## **Response to Review Comments Prepared by Wilbert O. Thomas on behalf of FEMA Region X for the Skagit River Flood Frequency Analyses**

### **Introduction**

# High Water Marks Profile Plot at Concrete USGS Gauge Location

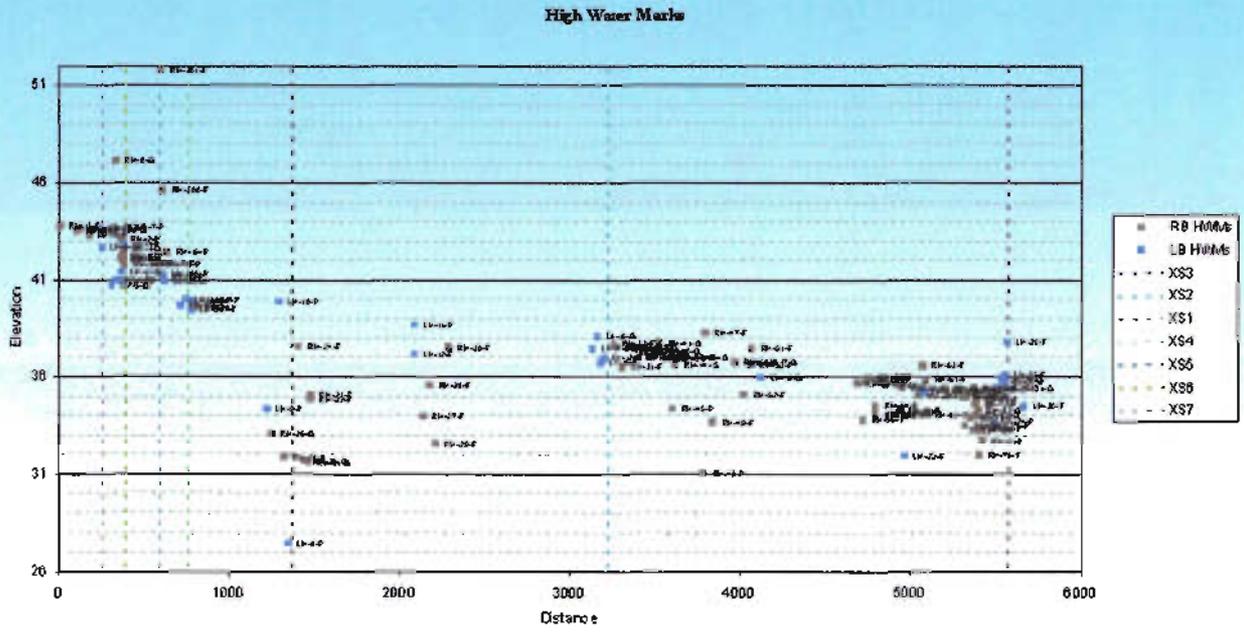
*Stating that "all subsequent estimates are generally within 20 percent of the USGS published values and within the uncertainty of peak discharges determined by indirect methods (slope areas and contracted-opening measurements)", the reviewer assumed that Stewart's high water marks (HWMs) were accurately converted from a hotel on the bank of the Baker River to the Dalles reach for the 1897, 1909, and 1917 floods. "All subsequent USGS estimates" referred to by the reviewer in this comment are also based on this assumption.*

*Stewart's transfer of HWMs was not clearly documented and likely not accurately performed. Stewart's high water marks for the other three unrecorded floods were at a hotel located "about one mile upstream" (Stewart and Bodhaine, 1961). The distance between the hotel and the Dalles is over 2.5 miles, while Stewart incorrectly assumed only one mile (Stewart and Bodhaine, 1961). The water surface gradient PIE developed using a calibrated HEC-RAS model is over 5 ft/mile at the Dalles and at the hotel site. Stewart assumed 2 ft/mile (Stewart and Bodhaine, 1961). The HWM conversion could not be substantiated by any Stewart or USGS documents. USGS has stated it could not find in its files any supporting evidence of Stewart's HWMs and conversion calculations (PIE, 2005a).*

Stewart's estimate for the 1897 flood at Concrete is 45 percent higher than his estimate at Sedro-Woolley (275,000 cfs versus 190,000 cfs). The difference of peak flows at these two locations during a large flood should be within a four percent range, according to both the USACE and PIE's hydraulic models and observed floods. See the tables below for a comparison of concurrent flood peaks at these two locations. Stewart did not address this issue of coincident flow variation between the estimates for Concrete and Sedro-Woolley. Very little in-valley storage exists between these two gage locations. Both of the Stewart discharge estimates are published by the USGS, but they contain a conundrum that is central to the use of the historic flood data, and must be resolved. If the Sedro-Woolley estimates are accurate, then the Concrete discharge estimates are too high. On the other hand, if the Concrete estimates are accurate, then the written record would document much higher flood damage in the lower basin. This is not the case and therefore, we believe Stewart's estimates of the discharge at Sedro-Woolley are closer to the actual discharge.
